Temperature sensors on APAs

Introduction

- Few problems have been observed in RTD kits sent to Daresbury and Chicago. Many apologies to both for the inconveniences
- Kits not yet installed have been returned to IFIC and are being carefully inspected and repaired
- The path forward
 - 1.Characterise observed problems
 - 2.Repair existing kits
 - 3.Changes in production procedures for new kits
 - 4.Changes in QA/QC procedures for repaired/new kits
- These items will be covered in this talk

Problem 4: Misaligned holes in PCBs

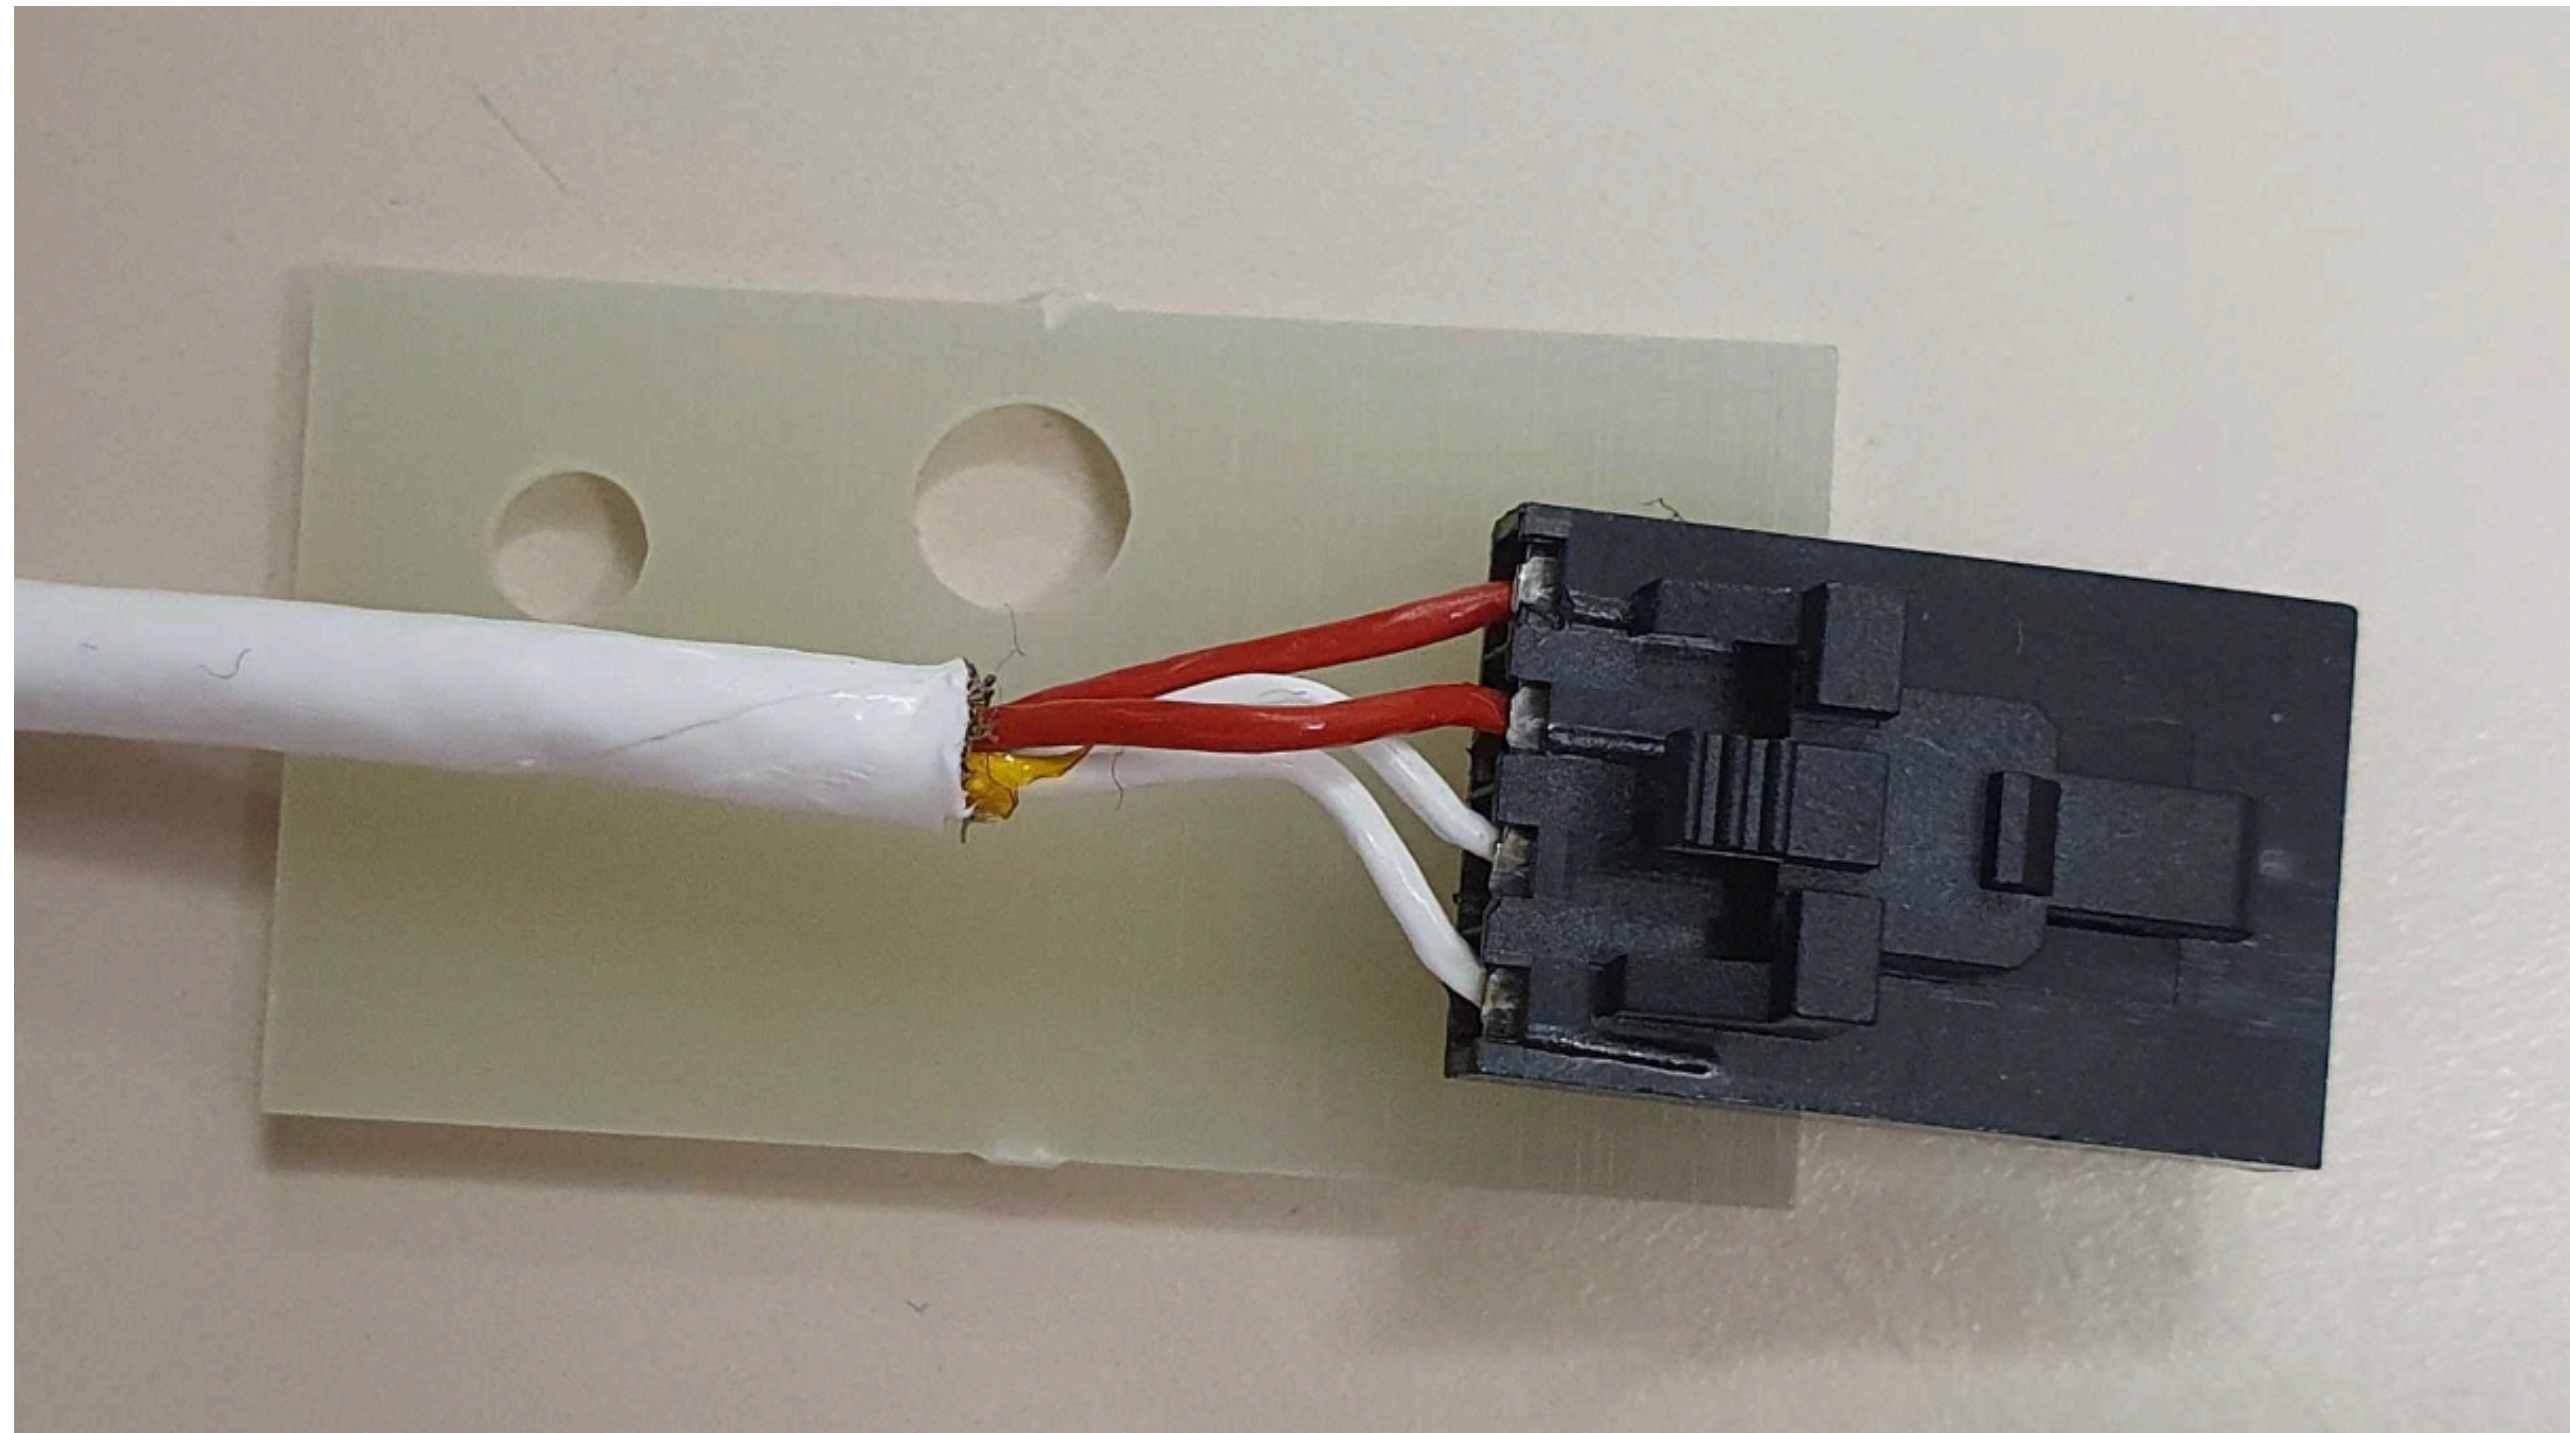
- The IDC-4 female connector is glued with loctite super glue-3 on the cable PCB. This is done manually, and alignment is done by eye

Problem 4: Misaligned holes in PCBs

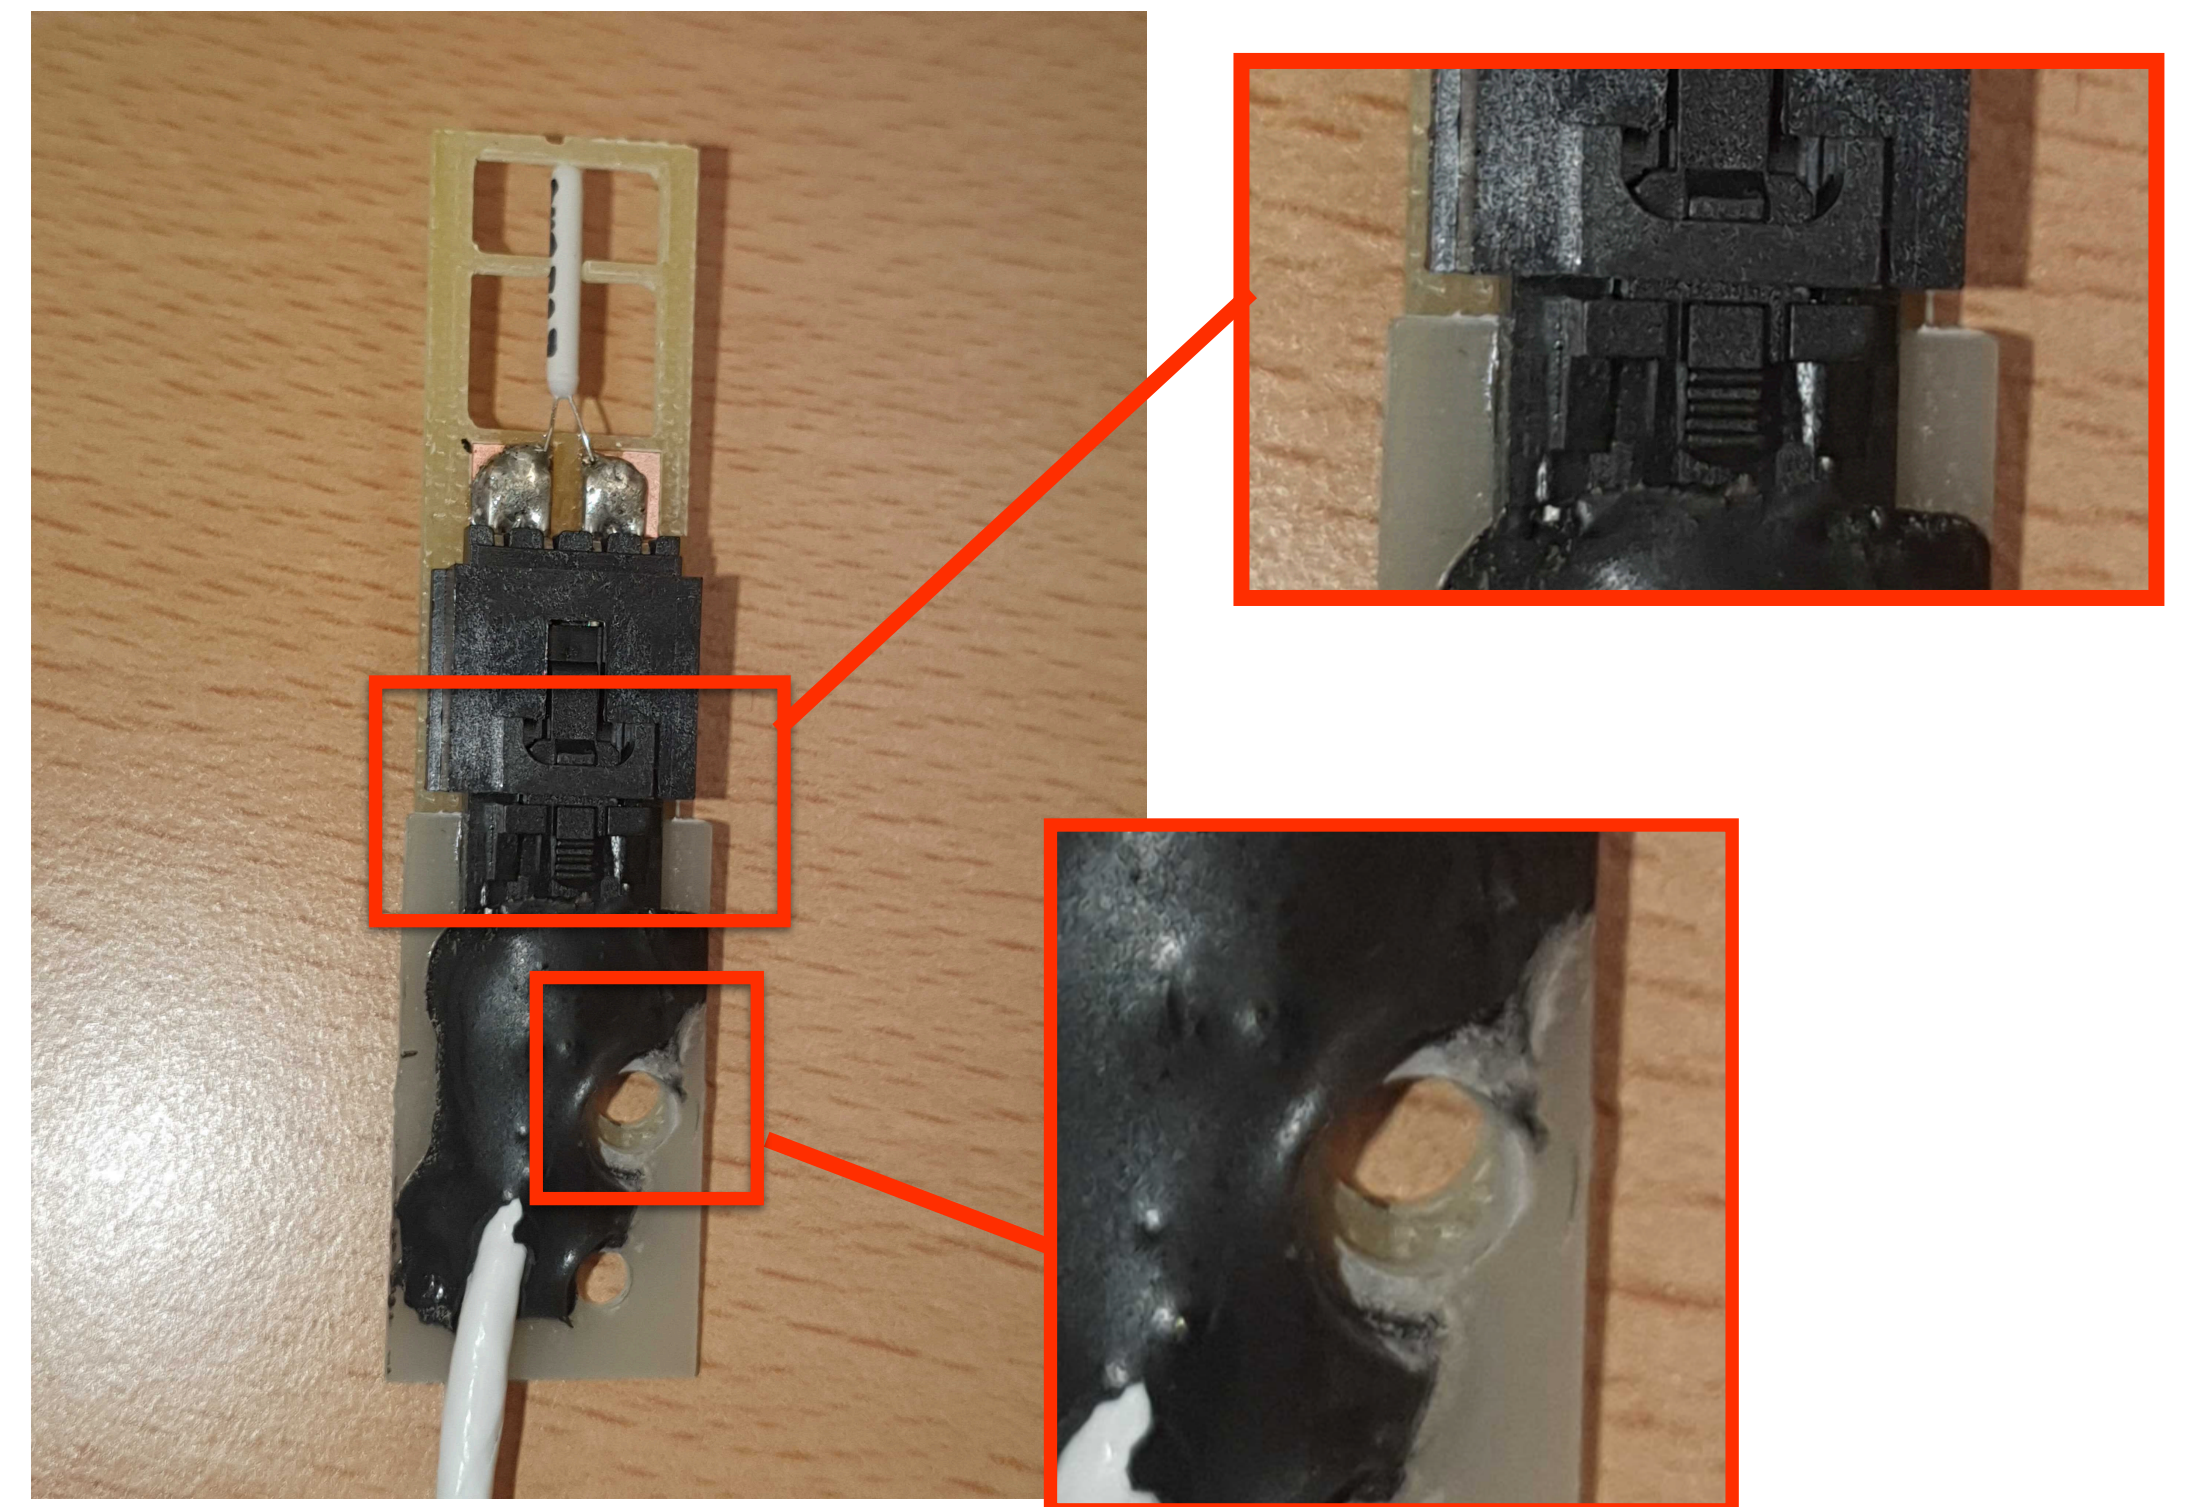
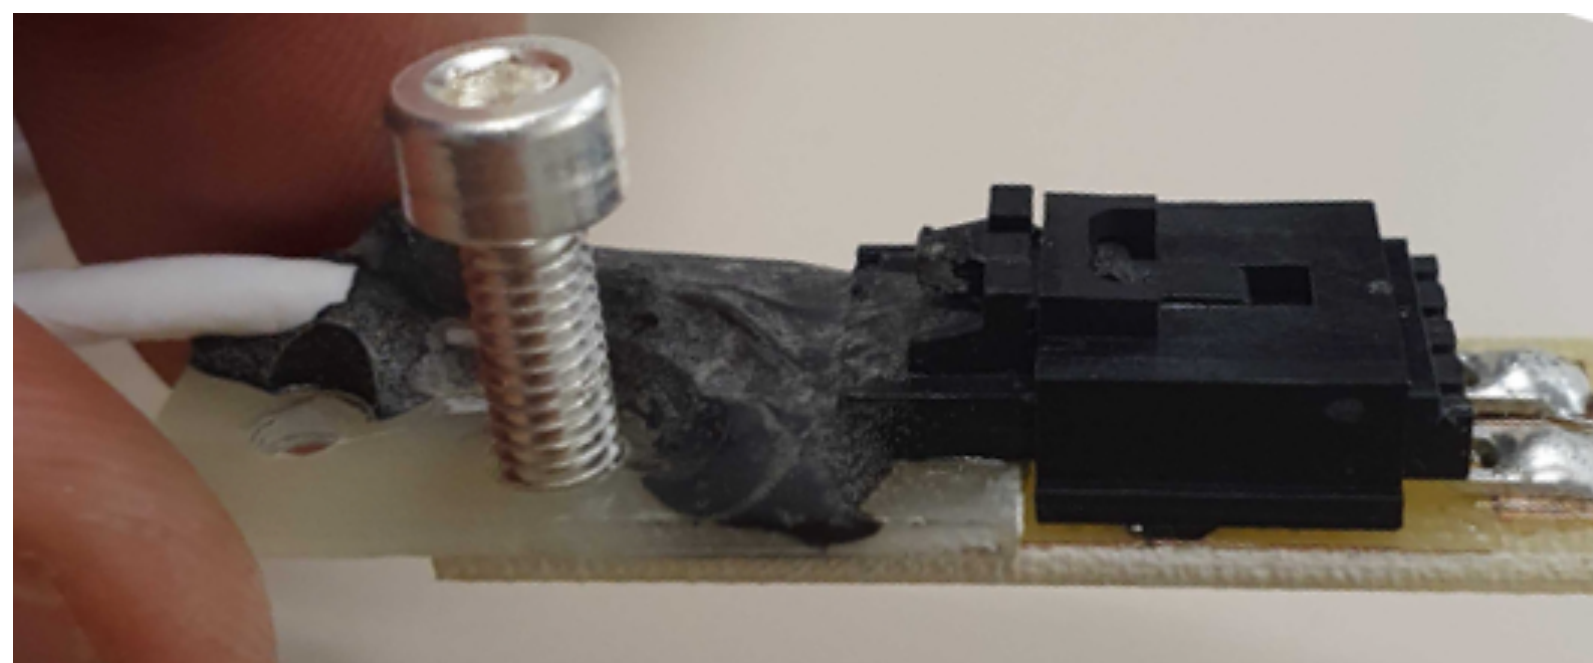
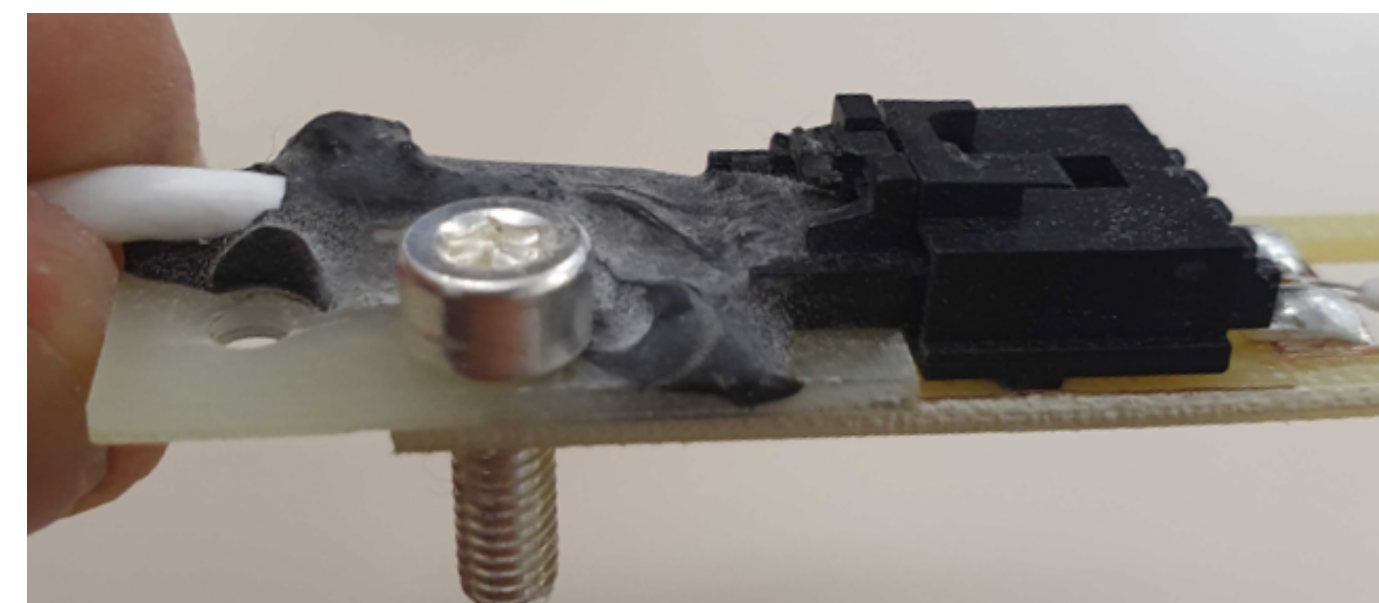
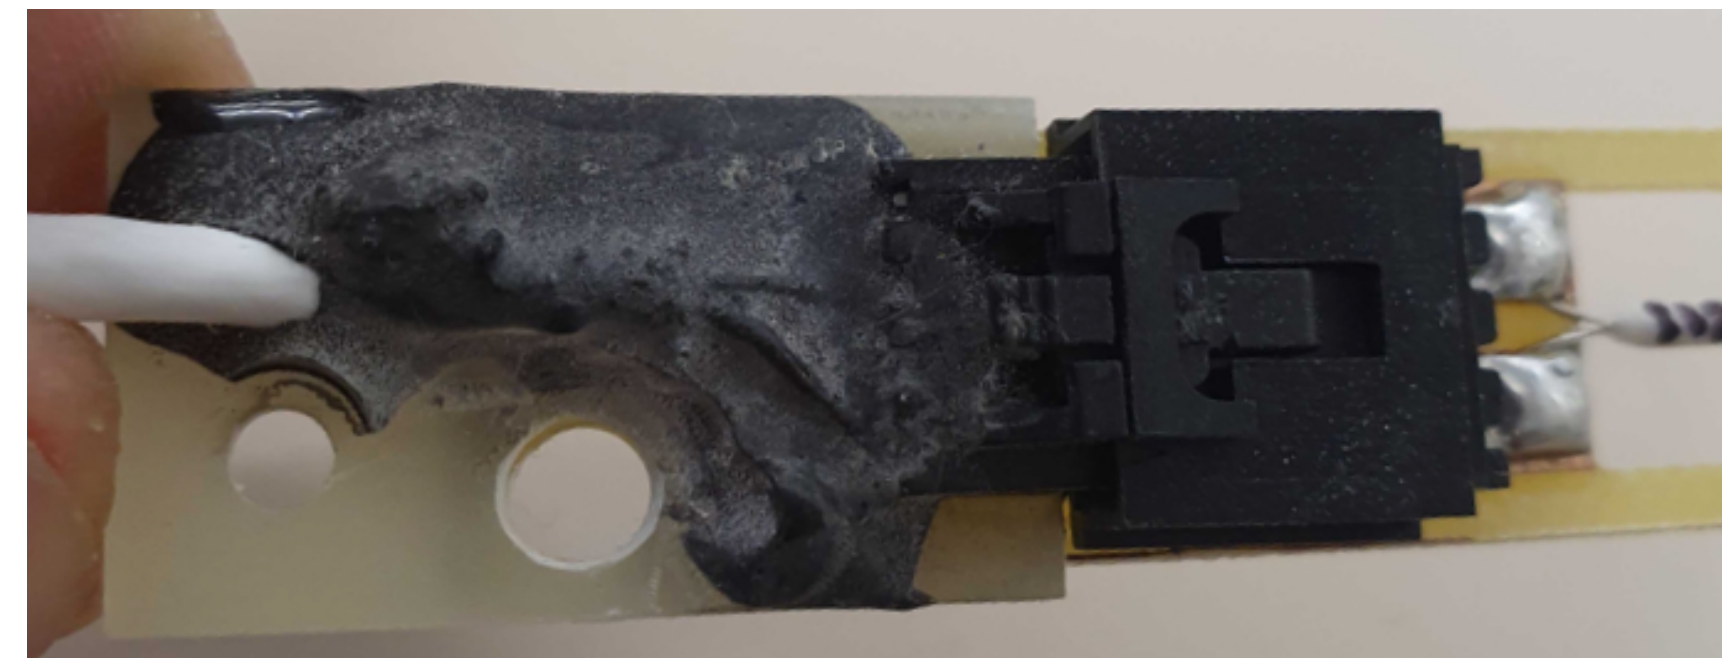
- In some cases the alignment is not correct and once the sensor is plugged in the holes of the two PCBs doesn't match each other

- **Repair:** Use a cylindrical lime to increase the size of hole in lower PCB
- **Changes in production:** A special tool where the cable PCB and the IDC-4 female connector are placed before gluing is been fabricated
- **Changes in QA/QC:** Mount the entire kit
